16 ZON2009-00006

ZONING AMENDMENT STAFF REPORT Date: February 5, 2009

LOCATION 1217 Government Street

CONTEMPLATED USE Rezoning from B-1, Buffer Business District, to B-1,

SITE PLAN

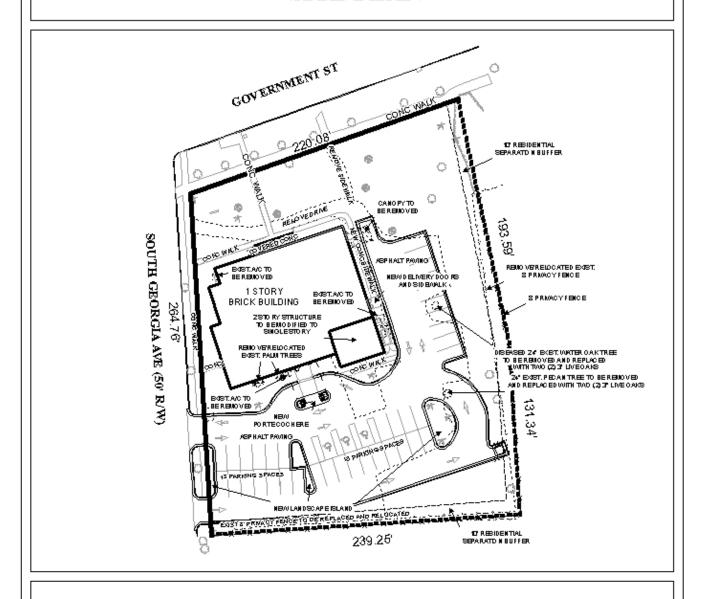
Driveway number, size, location, and design to be approved by Traffic Engineering and conform to AASHTO standards. One-way aisle width does not provide adequate aisle width for ninety-degree parking stalls. The required aisle width for ninety-degree parking is twenty-four feet. Standard driveway widths for one-way drives are sixteen feet. Both driveways should be narrowed to sixteen feet with twenty foot radii and converted to one-way only traffic with traffic entering through the southern drive and exiting from the northern drive. The parking aisles on the southern parking lot should be changed to angle parking to accommodate the narrow aisle width.

As per the applicant, the changes will be as follows: "modification of the parking lot, a relocated porte-cochere, generator pad and enclosure, and dumpster pad and enclosure." The applicant further states that the second story portion of the structure on the southeast corner of the building will be removed and the exterior walls will be made to match existing walls. The applicant further states that new landscaping in compliance with the ordinance will be provided.

As the proposed use of medical office is the same as the previous use at the site, and the fact that the site will be reduced in scope, as well as renovated, amending the rezoning would seem to be appropriate. One concern is the location of the new dumpster pad and enclosure. Section 64-4.D.1 of the Zoning Ordinance requires a protection buffer strip of 10 feet where commercially zoned property abuts residentially zoned property. In this case, the dumpster pad and enclosure are shown to be within the 10 foot protection buffer, and therefore, the dumpster pad and enclosure should be relocated outside of the 10 foot buffer.

- 1) Provision of a buffer in compliance with Section 64-4.D.1 of the Zoning Ordinance;
- 2) Relocation of the dumpster pad and enclosure outside of the 10 foot buffer;

- 3) Compliance with Section 64-6.A.3(i) of the Zoning Ordinance regarding parking lot screening;
- 4) Approval from the Architectural Review Board for all exterior work, to include buffer fencing;

- 5) Compliance with traffic engineering comments: One-way aisle width does not provide adequate aisle width for ninety-degree parking stalls. The required aisle width for ninety-degree parking is twenty-four feet. Standard driveway widths for one-way drives are sixteen feet. Both driveways should be narrowed to sixteen feet with twenty foot radii and converted to one-way only traffic with traffic entering through the southern drive and exiting from the northern drive. The parking aisles on the southern parking lot should be changed to angle parking to accommodate the narrow aisle width;
